TECHNICS CD

Technical Information

MAY 1987

MODELS: SL-P520, SL-P720

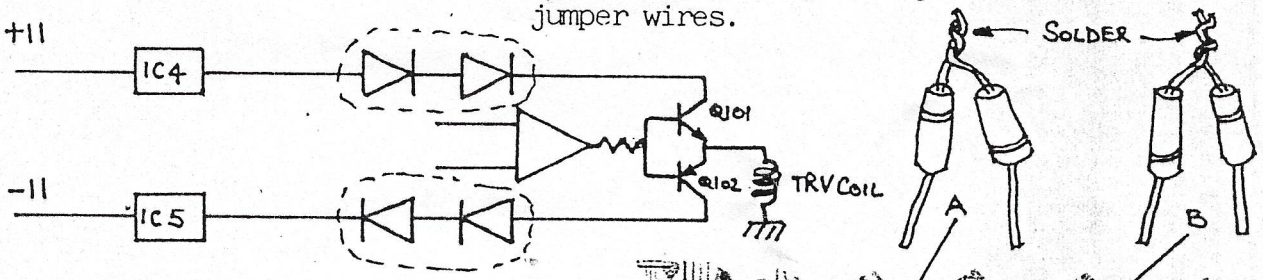
METHOD: (1) Replace Q11 and Q101 by 2SC1846
Q12 and Q102 by 2SA885
New transistors are larger and have to be fitted as shown.

(2) Add 4 diodes in series with connectors of transistors to reduce the voltage as shown.

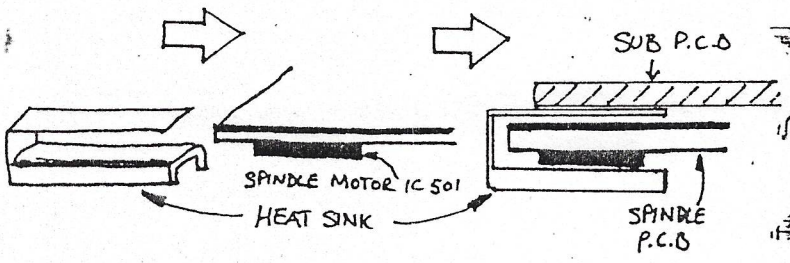
A & B diodes are put in place of jumper wires.

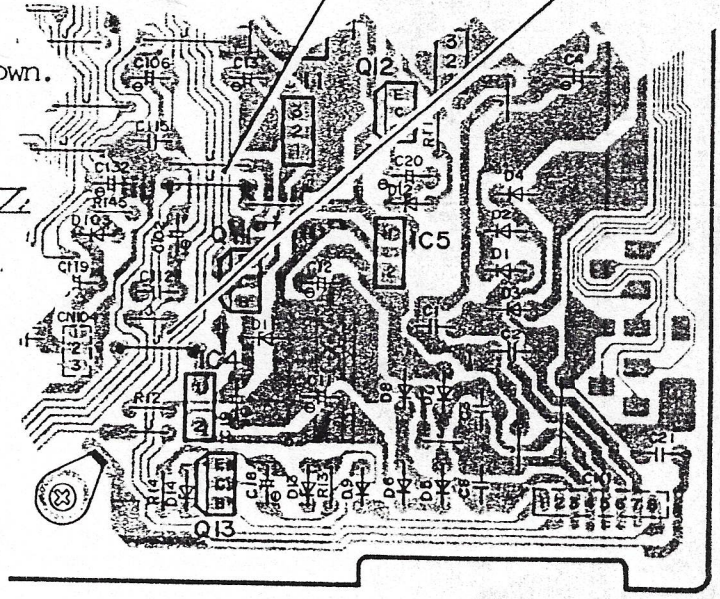
(3) Add heat sink to spindle IC501 as shown.

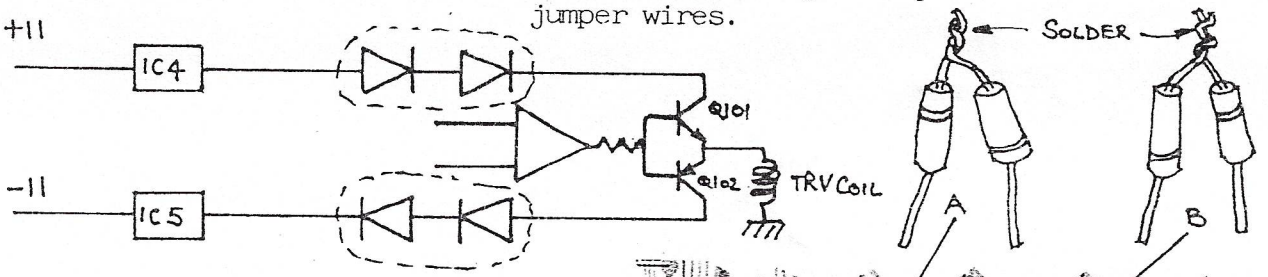
METHOD: (1) Replace Q11 and Q101 by 2SC1846
Q12 and Q102 by 2SA885
New transistors are larger and have to be fitted as shown.

(2) Add 4 diodes in series with connectors of transistors to reduce the voltage as shown.

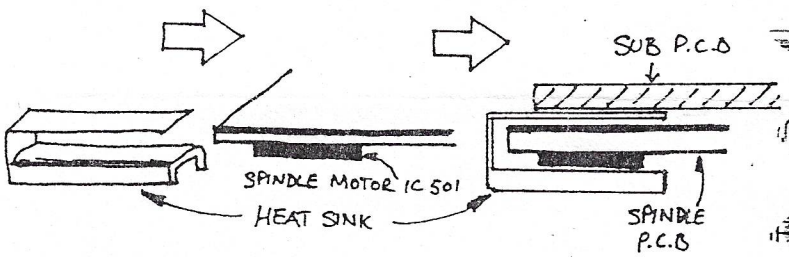
A & B diodes are put in place of jumper wires.

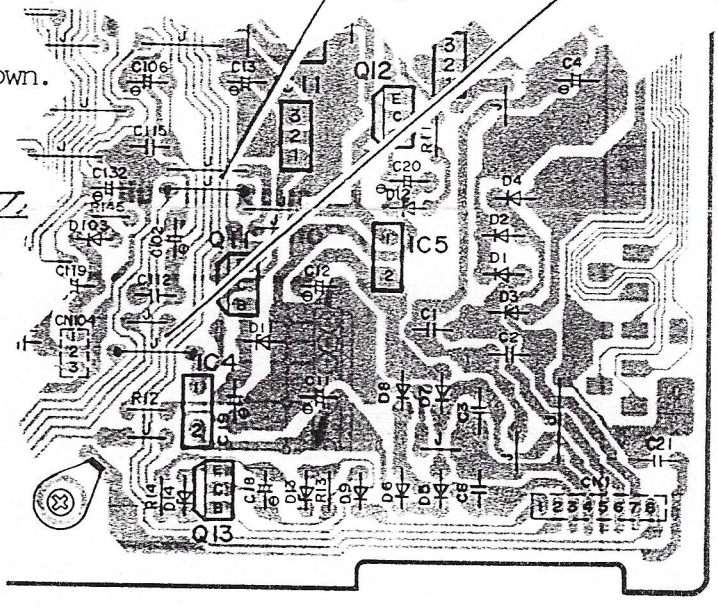
(3) Add heat sink to spindle IC501 as shown.

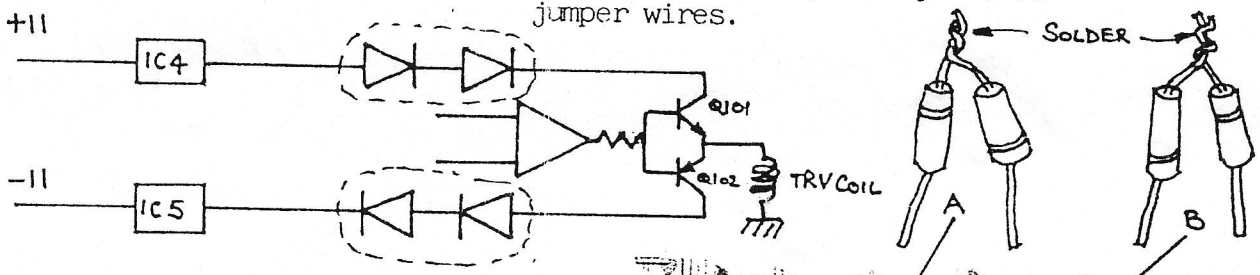
METHOD: (1) Replace Q11 and Q101 by 2SC1846
Q12 and Q102 by 2SA885
New transistors are larger and have to be fitted as shown.

(2) Add 4 diodes in series with connectors of transistors to reduce the voltage as shown.

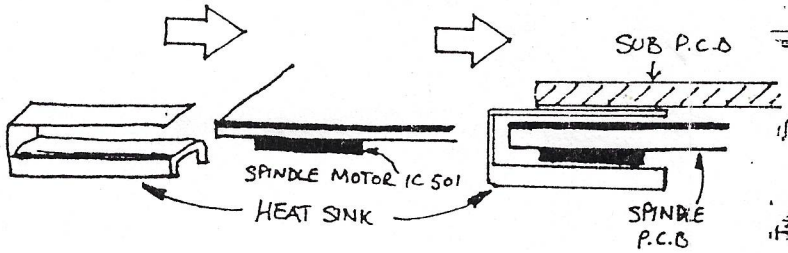
A & B diodes are put in place of jumper wires.

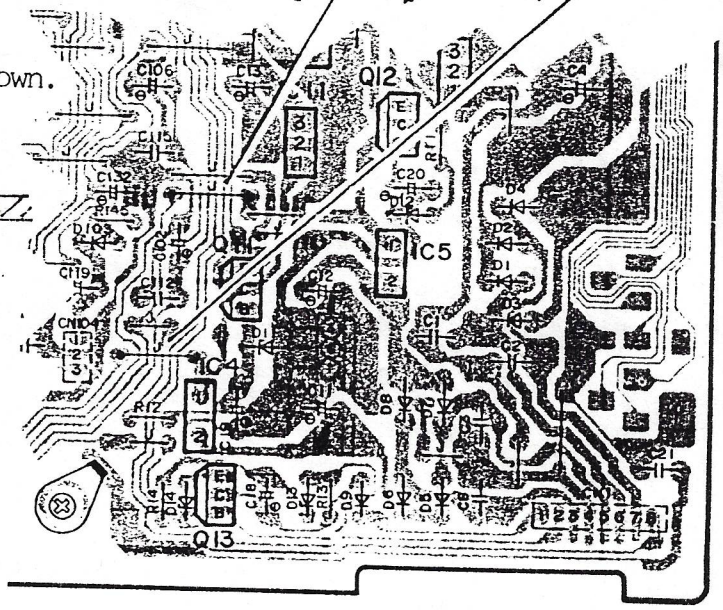
(3) Add heat sink to spindle IC501 as shown.
